**AESTHETIC SURGERY ASSOCIATES PROPOSED MEDICAL OFFICE
BUILDING
MAJOR PLAN 2023-106
ATTACHMENTS**

TO: PLANNING COMMISSION
FROM: GREGG ADAMS, PLANNER
SUBJECT: AESTHETIC SURGERY ASSOCIATES PROPOSED MEDICAL OFFICE BUILDING
MAJOR PLAN 2023-106
REQUEST FOR PRELIMINARY/FINAL PLAN REVIEW
DATE: APRIL 5, 2024
COPIES: BOARD OF COMMISSIONERS, T. PETRUCCI, D. MANHARDT, L. HARRIER, L. PEREIRA, ESQ, A. TALLARIDA, S. PIDCOCK, APPLICANT, SUB. FILE 2023-106

SUBJECT: South Whitehall Township
 Aesthetic Surgery Associates MOB
 Major Plan #2023-106
 Preliminary/Final Plan Review

SHEET TITLE:
**UTILITY
PLAN**
SHEET NUMBER:
C-501
REVISION 2 - 3/14/2024

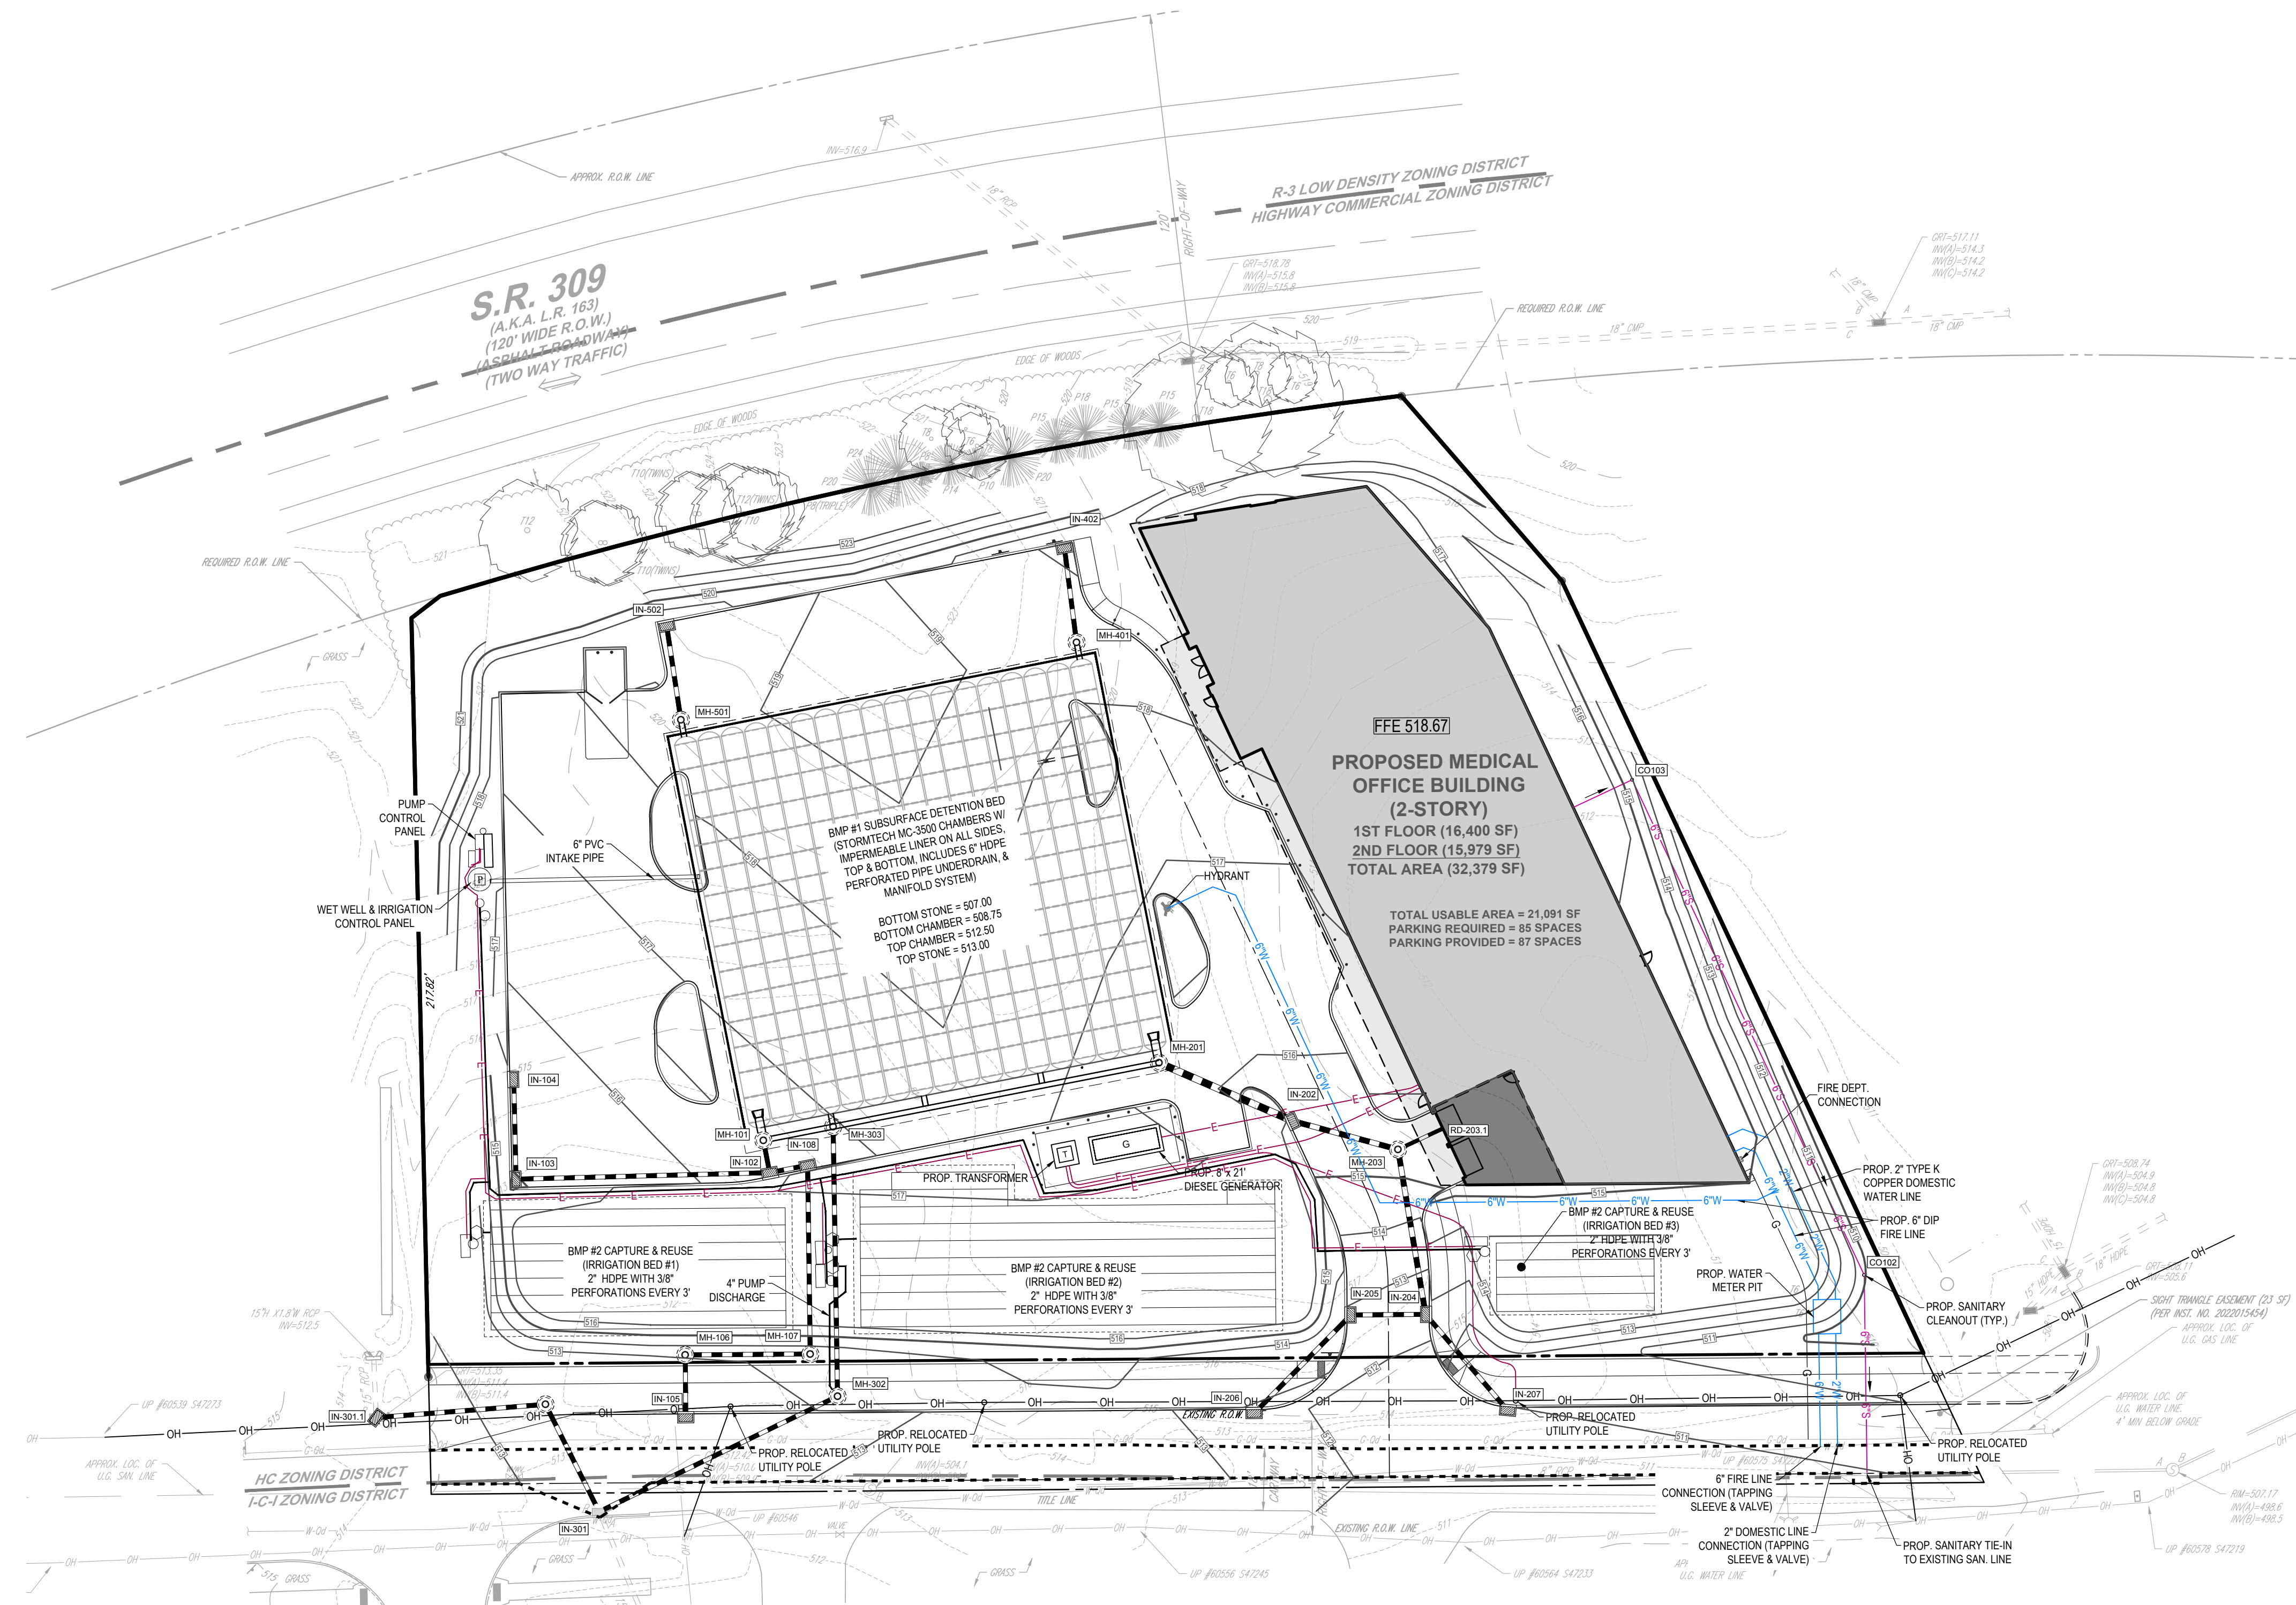
1. Utility Plan Sheet 501 Revision 2 - 03/14/2024: 12" water line is shown in appears to be in the wrong location. Determine the existence and positions of the SWT 12" water main, which we believe to be outside of the paved area of Hausman Rd.
